NPE-88/05

REACTIVITY CONTROL SYSTEMS

3/4.1.5 STANDBY LIQUID CONTROL SYSTEM

FIGURE 3.1.5-1 SODIUM PENTABORATE SOLUTION TEMPERATURE/CONCENTRATION REQUIREMENTS

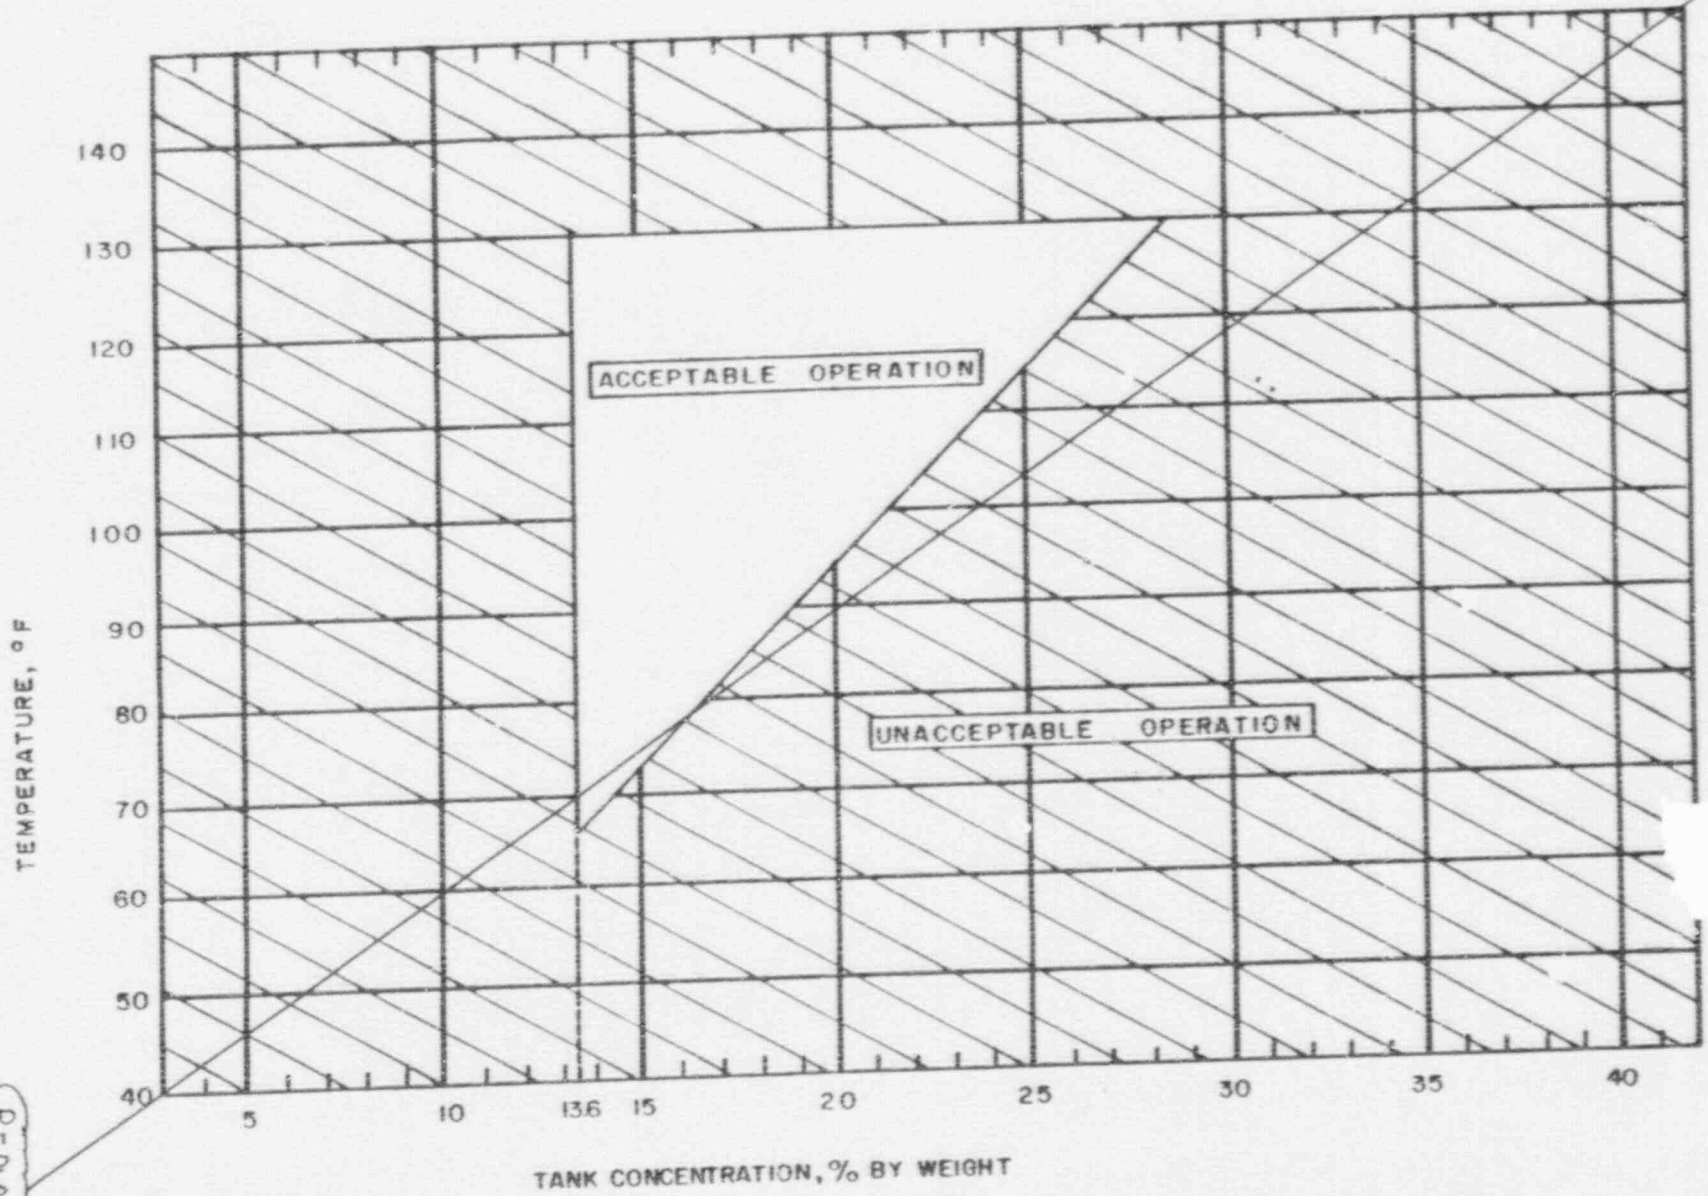
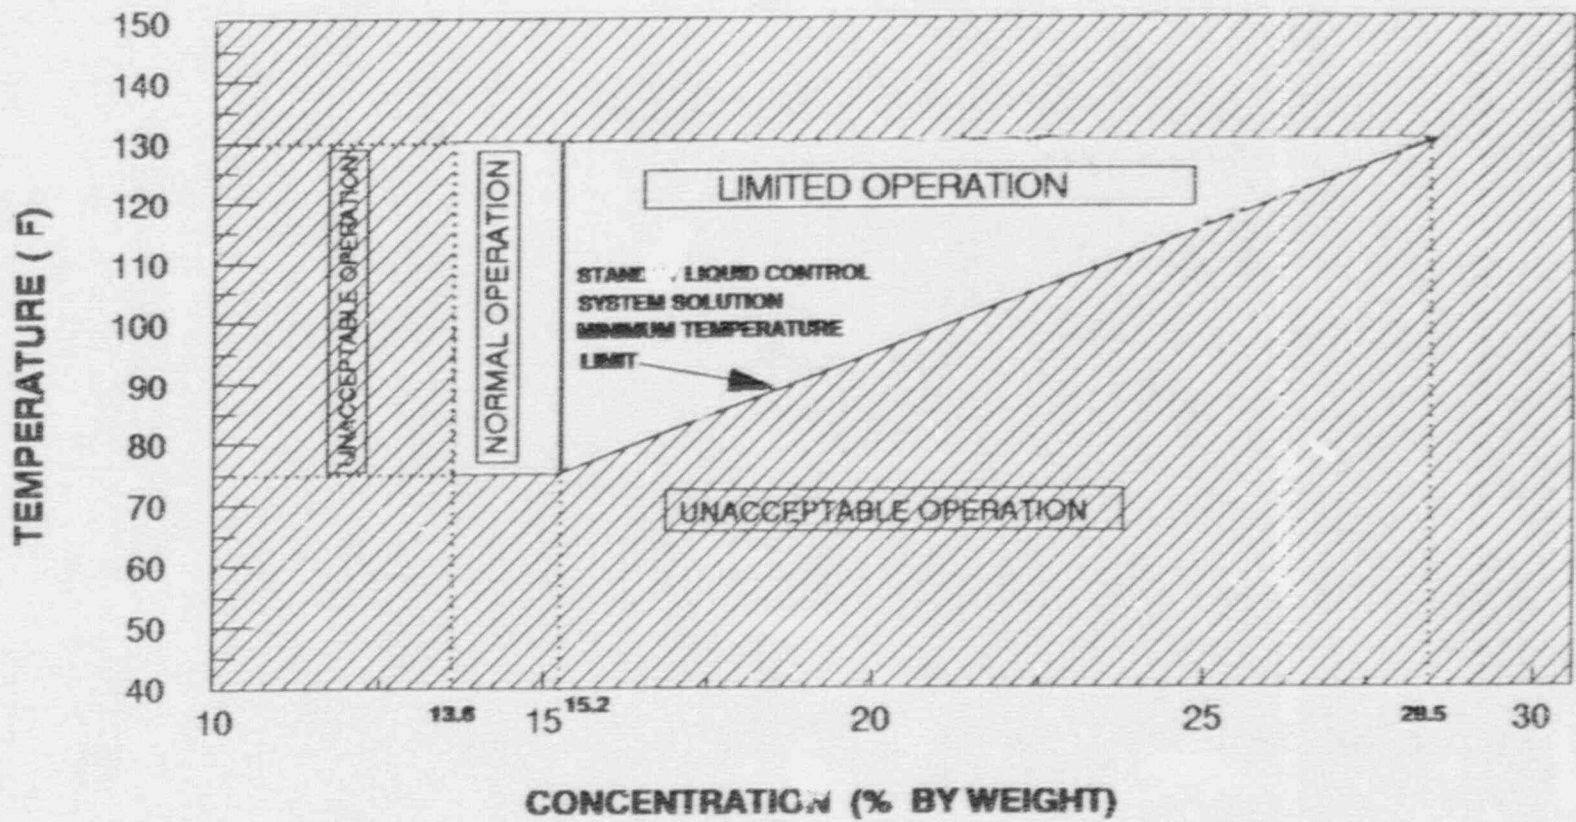
1. The temperature of the sodium pentaborate solution is ~~within the limits of Figure 3.1.5-1.~~ <sup>INSERT B</sup>
2. The available volume of sodium pentaborate solution is ~~greater than or equal to 4530 gallons.~~ <sup>INSERT C</sup>
3. The heat tracing ~~circuit~~ is OPERABLE by determining the temperature of the pump suction piping is ~~within the limits of figure 3.1.5-1.~~ <sup>INSERT D</sup>

\*This test shall also be performed anytime water or boron is added to the solution or when the solution temperature drops below ~~the limit of~~ 75°F  
~~Figure 3.1.5-1.~~ the suction piping temperature is

REPLACE ENTIRE FIGURE

Temperature surveillance requirements are established on a frequency that assures a high probability that the solution temperature remains above the saturation temperature as illustrated by Figure 3.1.5-1. More frequent surveillance is required when operating in the "Limited Operation" region of Figure 3.1.5-1 because of decreased margin to saturation.

FIGURE 3.1.5-2  
 SODIUM PENTABORATE SOLUTION CONCENTRATION/AVAILABLE VOLUME REQUIREMENTS

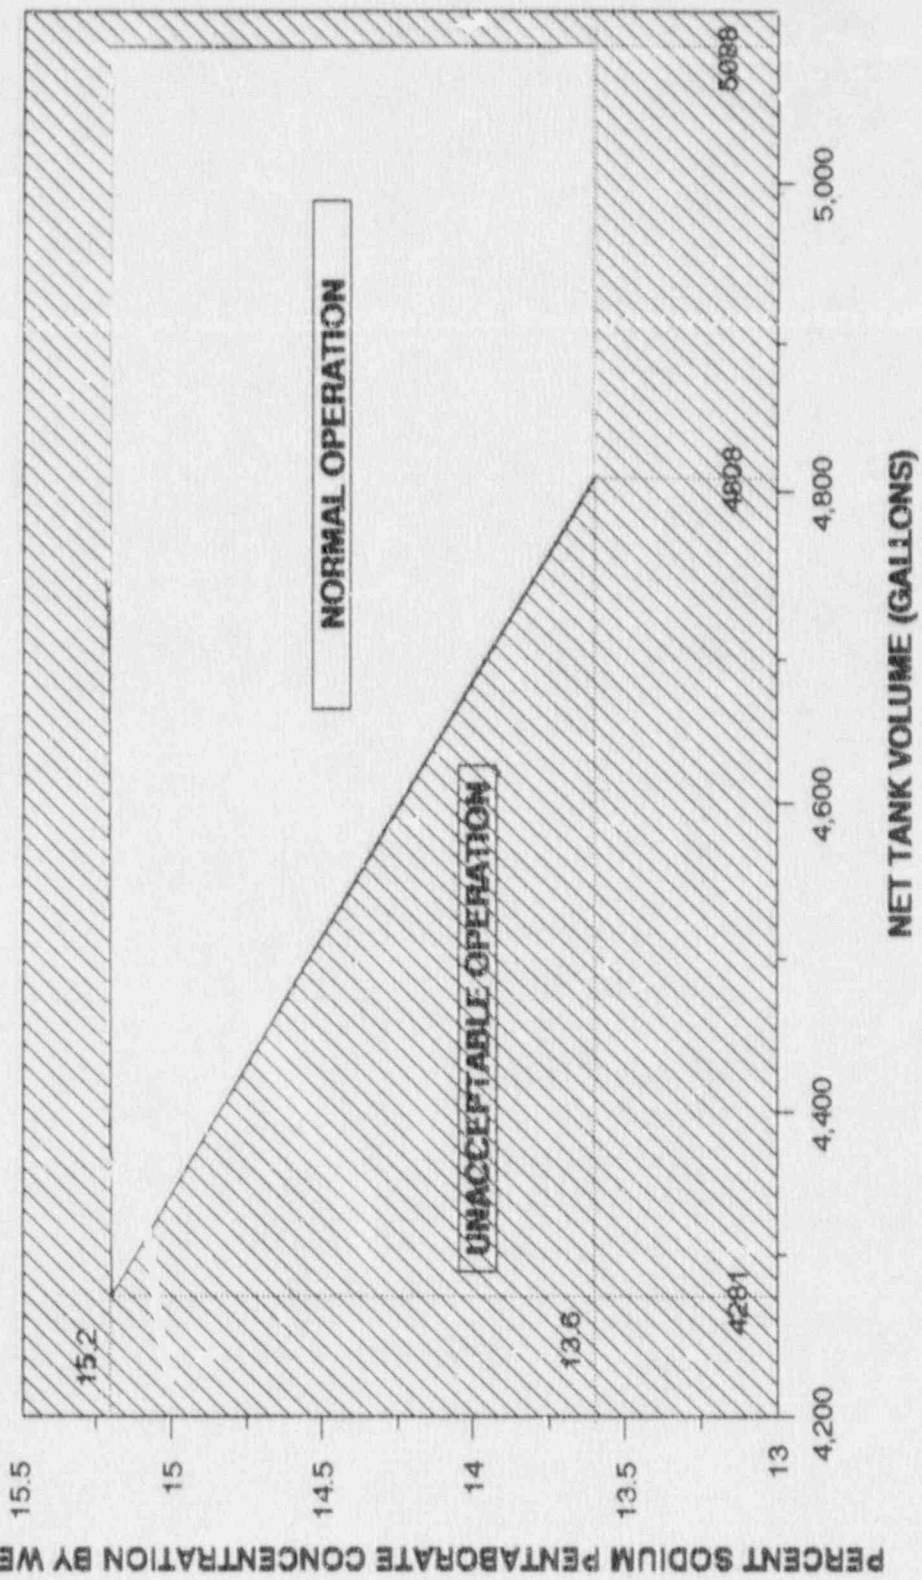
within the limits of Figure 3.1.5-2.

The sodium pentaborate solution is required to be maintained above the minimum required concentration and below the maximum allowable concentration on Figure 3.1.5-2.

The sodium pentaborate solution volumes specified in ACTION a.3 and Figure 3.1.5-2 are based on a 90°F nominal sodium pentaborate solution temperature.
